# Current ENERGY STAR Certified Homes Policy Record

## ENERGY STAR Certified Homes Policy Record

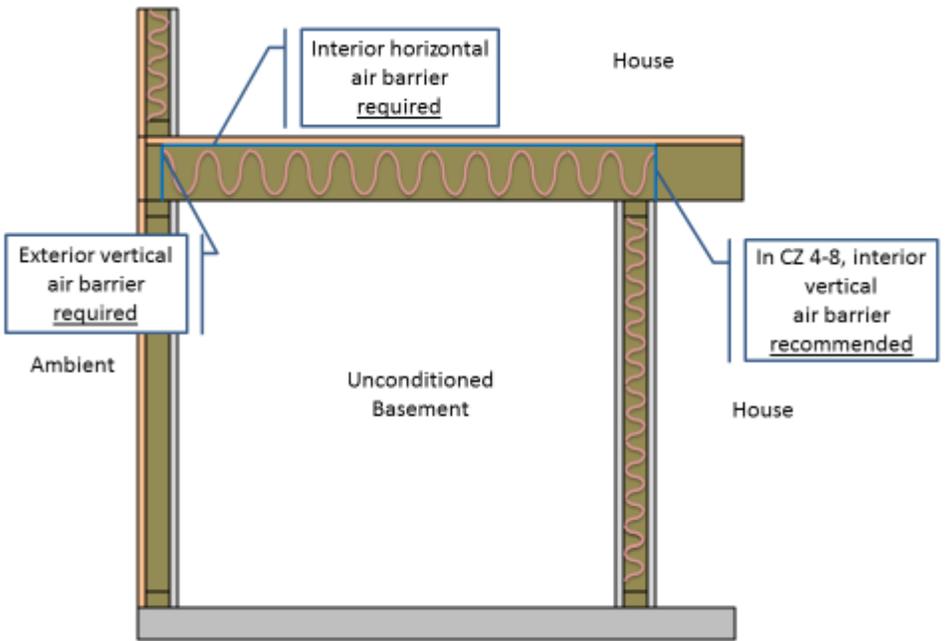
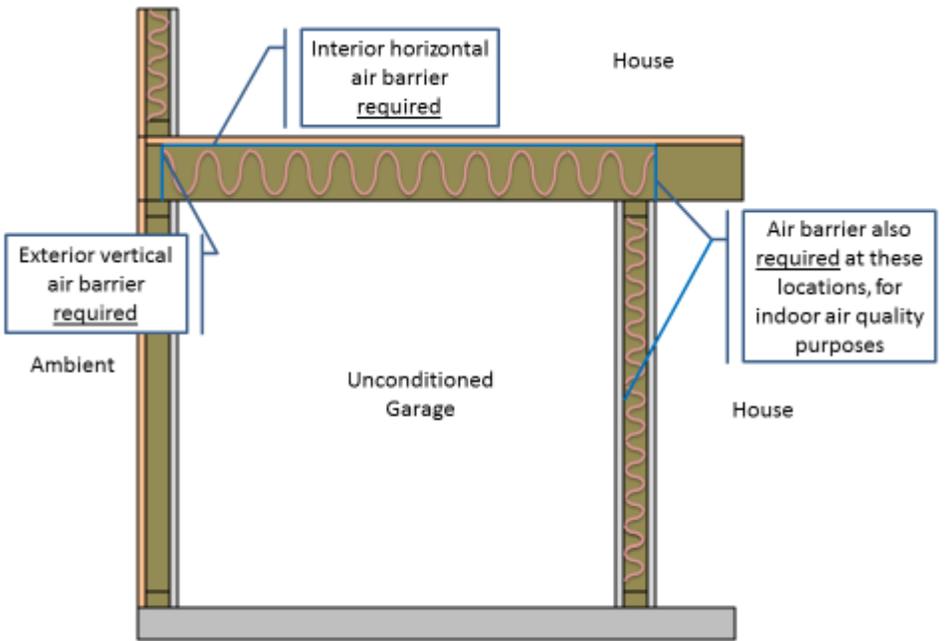
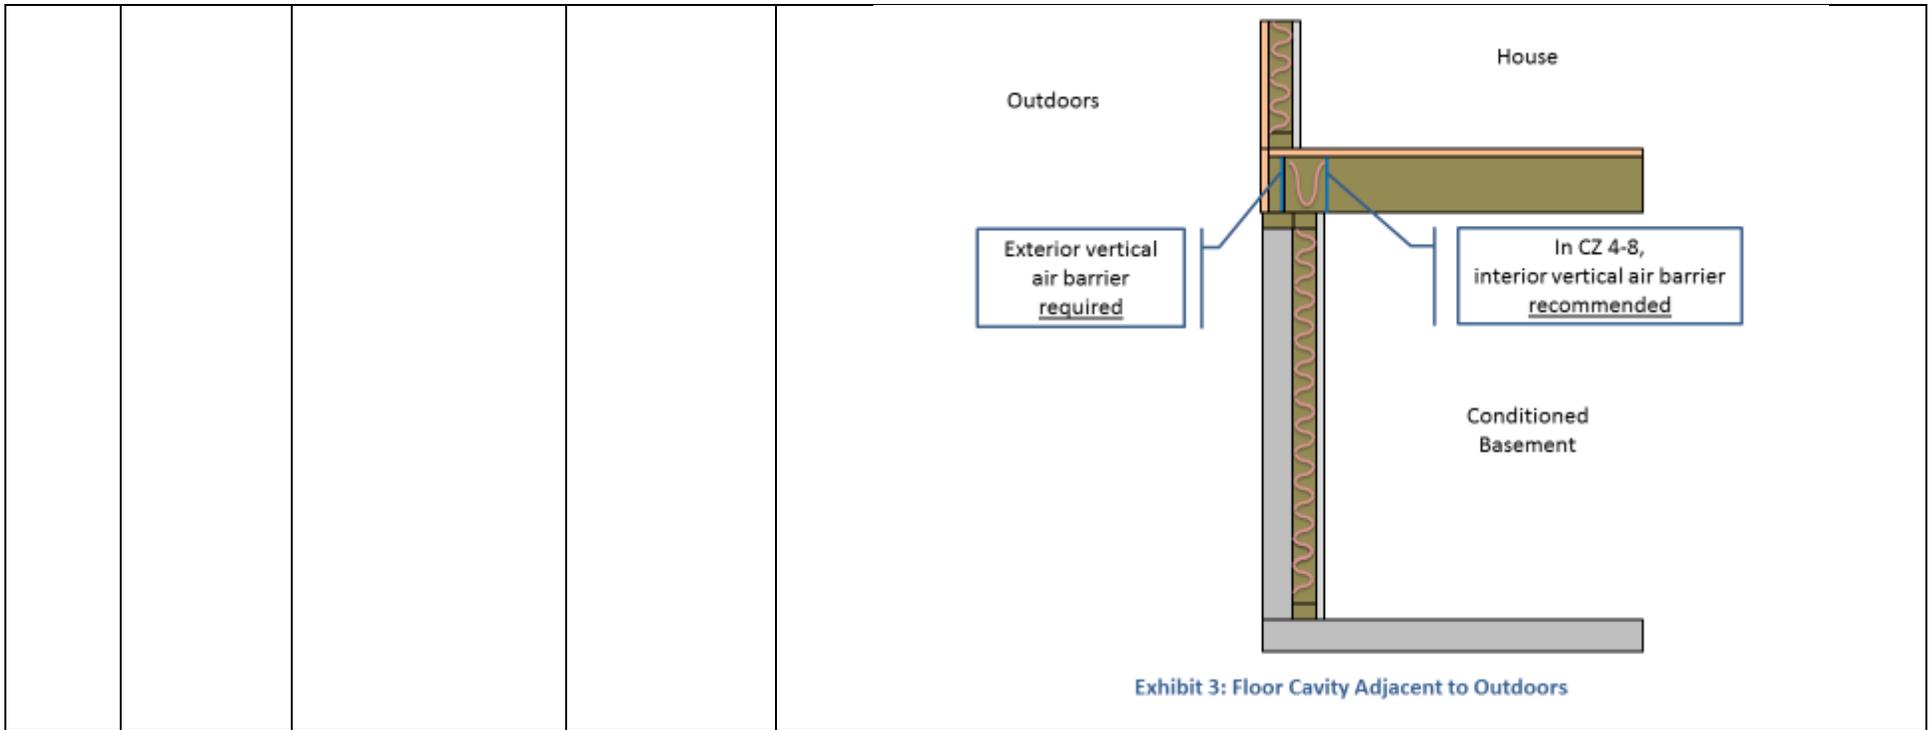
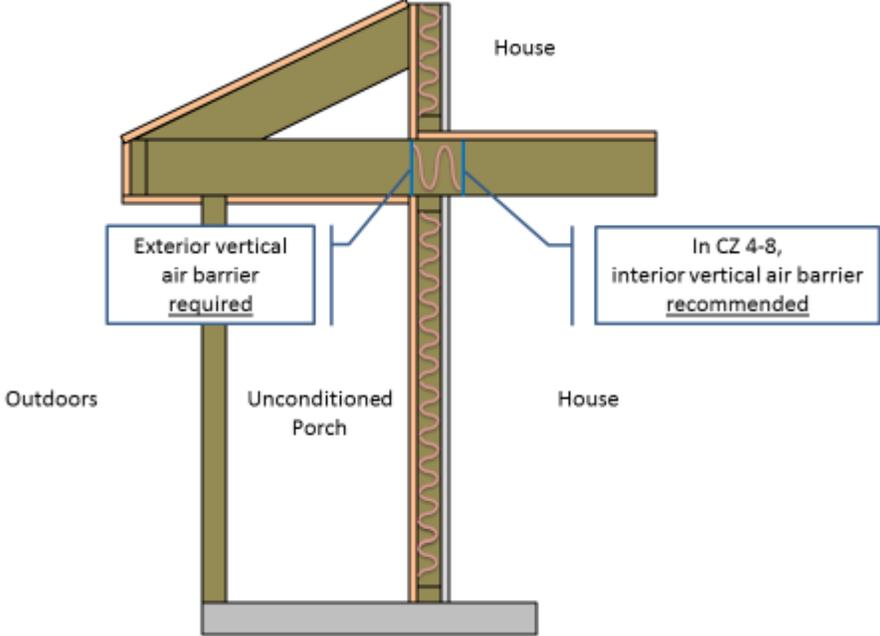
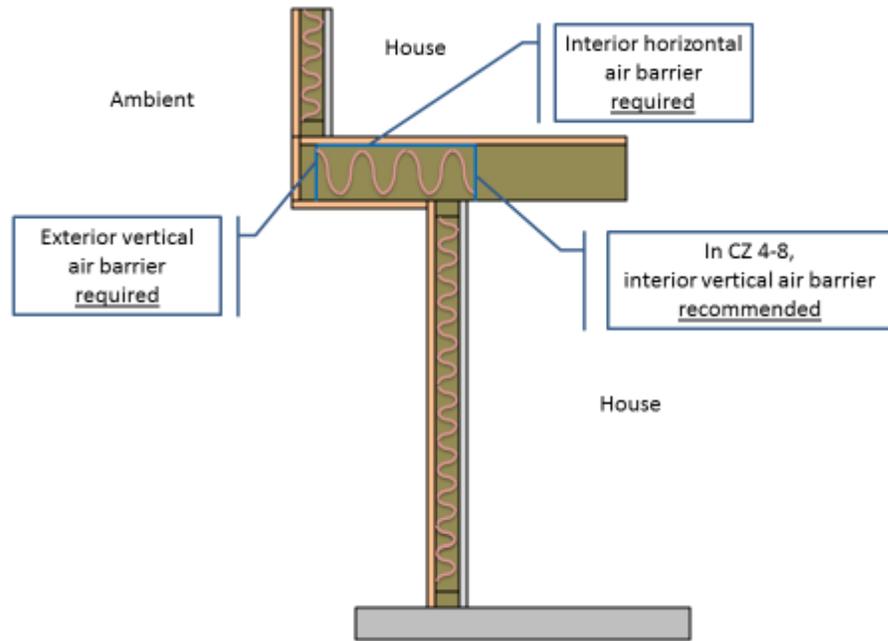
00467	07/01/2015	Thermal Enclosure System Rater Checklist (Version 3, Rev. 07)	Clarification	<b>Section 3, Footnotes 8 &amp; 9 – Clarified intent of air barrier configurations</b>
				<b>Issue:</b> Partners have asked for clarification regarding several aspects of the requirements for fully-aligned air barriers in Section 3, including: <ul style="list-style-type: none"> <li>• What the required orientation of the air barrier is for each assembly type (i.e., horizontal, vertical, or both),</li> </ul>

<ul style="list-style-type: none"> <li>Whether the requirements for walls in Item 3.1 actually also encompass rim joists and other floor cavities.</li> </ul> <p>Partners have also noted several inconsistencies in the terminology used throughout Section 3 and its Footnotes, such as “blocking at exposed edge”, which simply implies a vertical air barrier at the exterior surface of the insulation.</p> <hr/> <p><b>Resolution:</b> To clarify the intended orientation of the air barrier for each assembly type, Section 3 will be edited to distinguish between vertical and horizontal air barriers for ceilings, walls, and floors, as well as to define the required locations of the air barriers relative to the surface of the insulation. The requirements for each component type (i.e., ceiling, walls, and floors) will be grouped with the details associated with that component (e.g., ceiling requirements will be grouped with the list of ceiling details that must be inspected).</p> <p>The requirements for floors will be clarified by:</p> <ul style="list-style-type: none"> <li>Relocating all floor details into the Floors Section</li> <li>Clarifying that an air barrier is always required at the exterior vertical surface of floor insulation</li> <li>Clarifying that an air barrier is also required at the interior horizontal surface of the floor insulation, if located over unconditioned space.</li> <li>Clarifying that an air barrier is recommended, but not required, at the interior vertical surface of all floor insulation in CZ 4-8.</li> </ul> <p>In addition, the language regarding wind baffles at ceiling insulation will be made more consistent.</p> <p>Finally, the phrase, “blocking at exposed edge” in the section on floors will be rephrased as a requirement for an air barrier at the “exterior vertical surfaces of floor insulation”. The revised language in Section 3 will be as follows:</p> <p>“At each insulated location below, a complete air barrier shall be provided that is fully aligned as follows:</p> <ul style="list-style-type: none"> <li><u>Ceilings:</u> At interior or exterior horizontal surface of ceiling insulation in Climate Zones 1-3; at interior horizontal surface of ceiling insulation in Climate Zones 4-8. Also, at exterior vertical surface of ceiling insulation in all climate zones (e.g., using a wind baffle that extends to the full height of the insulation in every bay or a tabbed baffle in each bay with a soffit vent that prevents wind washing in adjacent bays)</li> <li><u>Walls:</u> At exterior vertical surface of wall insulation in all climate zones; also at interior vertical surface of wall insulation in Climate Zones 4-8</li> </ul>

<ul style="list-style-type: none"> <li>• <u>Floors</u>: At exterior vertical surface of floor insulation in all climate zones and, if over unconditioned space, also at interior horizontal surface including supports to ensure alignment. See Footnotes 10 and 11 for alternatives”</li> </ul> <p>The following details within each section will be modified:</p> <p>Walls:</p> <ul style="list-style-type: none"> <li>• Item 3.1.5 will be revised to state, “Walls adjoining porch roofs or garages”</li> <li>• Item 3.1.8, garage rim / band joist adjoining conditioned space, will be deleted and a new Item added to the Floors Section to address this detail.</li> </ul> <p>Floors:</p> <ul style="list-style-type: none"> <li>• A new Item will be added to address rim / band joists and other floors that are adjoining unconditioned space: “<u>All other floors adjoining unconditioned space (e.g., rim / band joists at exterior wall or at porch roof)</u>”</li> </ul> <p>Per Policy Record Entry 00428, Footnotes 7 &amp; 10 will be merged and renumbered to improve clarity and reflect new exemptions to the requirement for interior air barriers in basements. This new Footnote will be further modified as follows:</p> <p>“All insulated vertical surfaces are considered walls (e.g., above and below grade exterior walls, knee walls) and must meet the air barrier requirements for walls. The following exceptions apply: air barriers recommended, but not required, in adiabatic walls in multifamily dwellings; and, in Climate Zones 4 through 8, an air barrier at the interior vertical surface of insulation is recommended but not required in basement walls or crawlspace walls. For the purpose of these exceptions, a basement or crawlspace is a space for which <math>\geq 40\%</math> of the total gross wall area is below-grade.”</p> <p>In addition, Footnote 7, which recommends the inclusion of an interior air barrier at rim / band joists in Climate Zones 4 through 8, will be refined to reflect this new policy and moved to Footnote 9 of the Rater Field Checklist, as follows:</p> <p>“EPA highly recommends, but does not require, an air barrier at the interior vertical surface of floor insulation in Climate Zones 4-8.”</p> <p>Exhibits 1 through 4 illustrate the clarified policy for floors.</p> <p>In Exhibit 1, the floor is adjacent to the outdoors and over an unconditioned basement. An air barrier is therefore required at the exterior vertical surface of the floor insulation and at the interior horizontal surface of the insulation. In addition, if the home was in CZ 4-8, an air barrier would also be recommended, but not required, at the interior vertical surface of the insulation.</p>

Footnote 8, which provides the alternative compliance option of completely filling a floor cavity in lieu of using insulation supports (e.g., staves, netting), will be revised by removing references to air barriers because the requirements are not intended to be any different when this alternative is used:

Finally, Footnote 9, which provides the alternative compliance option of aligning the air barrier with the exterior (instead of interior) horizontal surface of the floor insulation, will be revised to use consistent terminology regarding the required location of air barriers, as follows:

<p>“Alternatively, an air barrier is permitted to be installed at the exterior horizontal surface of the floor insulation if the insulation is installed in contact with this air barrier, the exterior vertical surfaces of the floor cavity are also insulated, and air barriers are included at the exterior vertical surfaces of this insulation.”</p>
00428	05/01/2014	Thermal Enclosure System Rater Checklist (Version 3, Rev. 07)	Change	<p><b>Item 3.1 – Removal of interior air barrier requirement in most basements &amp; crawlspaces</b></p>
				<p><b>Issue:</b> Partners in Climate Zones 4 through 8 have expressed difficulty meeting the requirement in Item 3.1 to include an interior air barrier on all below-grade exterior walls. The primary challenge has been identifying cost-effective materials that meet a confluence of program, code, and manufacturer requirements addressing resistance to airflow, vapor permeability, flame spread index, smoke-developed index, and exposure limits for ultraviolet light.</p>
